## **MINUTES OF THE MEETING**

**20 January 2000**

### Projects Reviewed

Seattle Center Master Plan Update  
Seattle Center Performance Hall  
Seattle Center Festival Pavilion  
Delridge Branch Library  
Holly Park Phase II: 37<sup>th</sup> Street Park

Seattle Center Festival Pavilion (L)

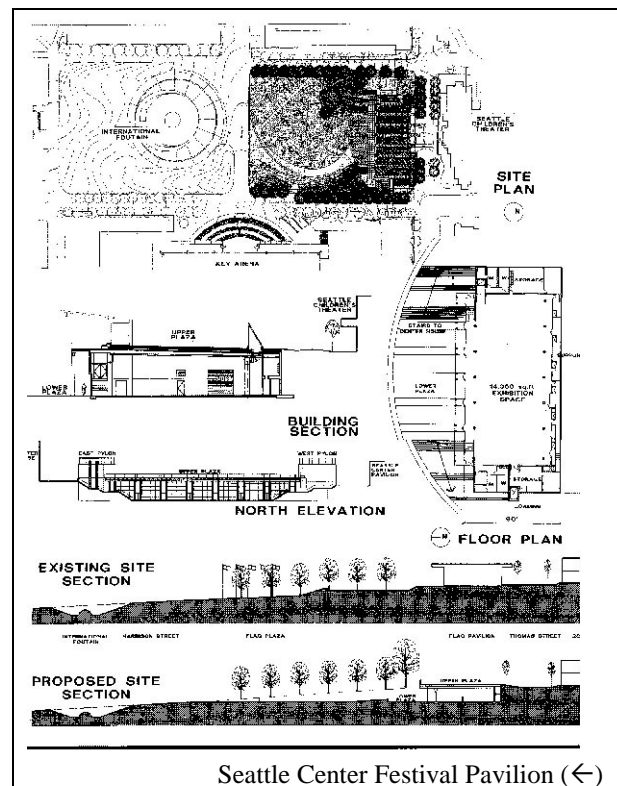
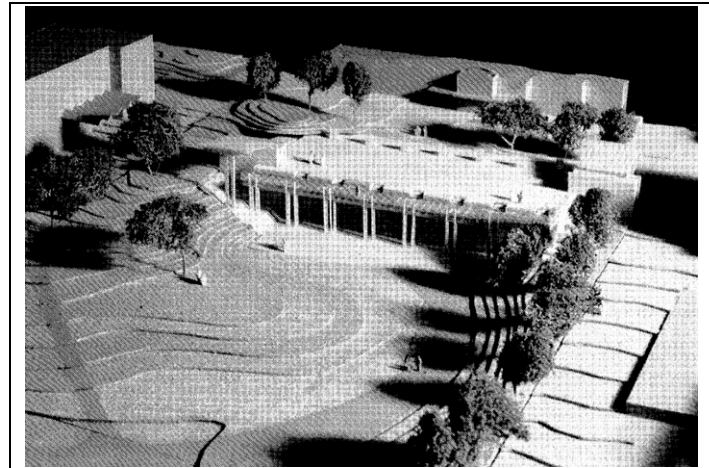
- The Commission supports the placement of a portion of the building below grade and of reclaiming the surface as open green space that extends to the International Fountain and Children's Theater;

- encourages the notion of the roof as a belvedere to the Fountain;
- supports the skylights as opportunities for special treatment while remaining functional as light wells that still encourage access to the Fountain and the Children's Theater;

- urges the landscape architect to study in more depth the south east and south west corners of the site to inform future design decisions;
- urges the team to revisit the issue of accessibility considering that all citizens should have the same type of experience and access to the site and the building;

- Feels that the proposal will unify the space and favors a naturalistic approach to the green space over a geometric one.
- Has concern with the level of circulation from the Fountain to the Center. Feels that the existing paths are restrictive and force the use of the more formal perimeter routes. Is also concerned with the level of accessibility of the interior spaces of the Pavilion. Feels that the visitors with mobility concerns would appreciate being able to move through

- Would like the team to look for ways to permeate the street intersection and to make a proposal for what this space can be. Similar to the pedestrian situation on Roy Street before the Performance Hall, the safer the pedestrian feels, the more they will want to be there.

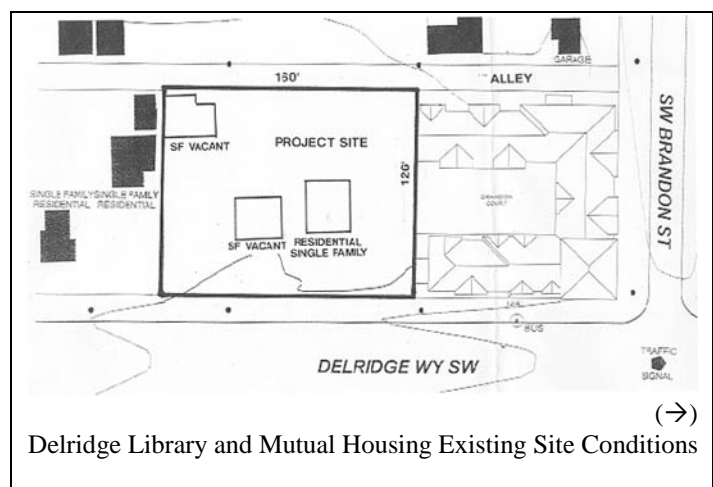
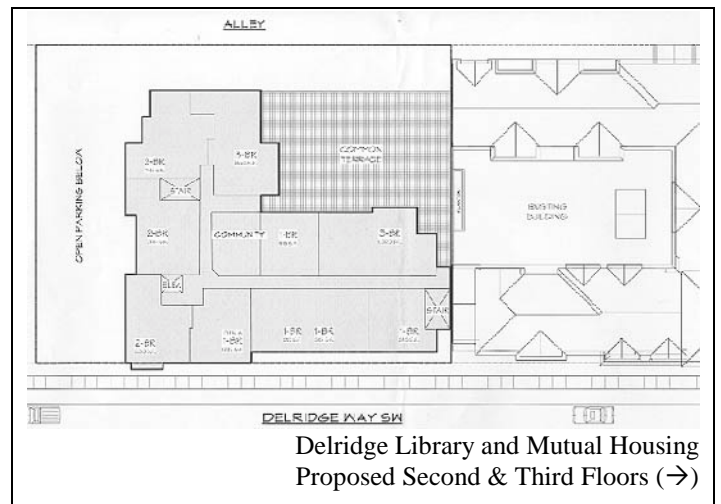
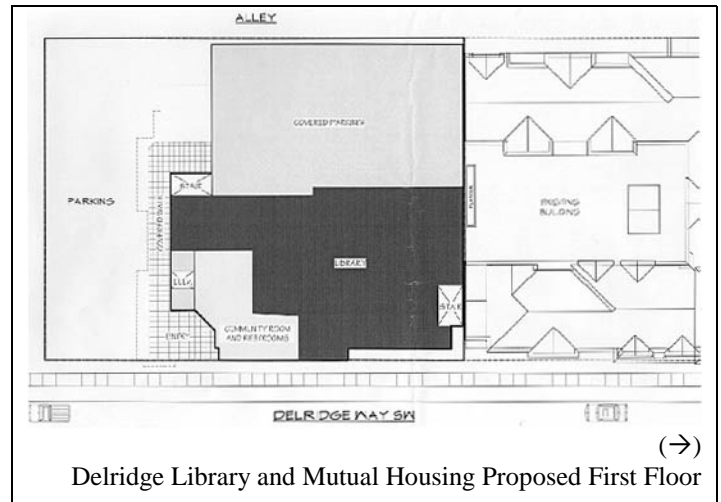
- **has the following concerns:**
    - **urges the team to minimize the visual impact of the entry drive to the parking area on the streetscape of Delridge Way South West;**

- Is concerned that the entry driveway infringes on the adjacent public space in front of the building entry and as such, does not allow for comfortable and spontaneous public gathering.

- Urges the team to consider integrating library patron pick-up and drop-off points and suggests that

the public entry court could bridge across the parking area in an effort to make the area look and feel more people oriented rather than car oriented.

- Proponents indicated that access from the rear alley will be difficult and that they cannot rely on it as a sole option.
- Urges the team to integrate the same level of green design that has been outlined for other library projects.
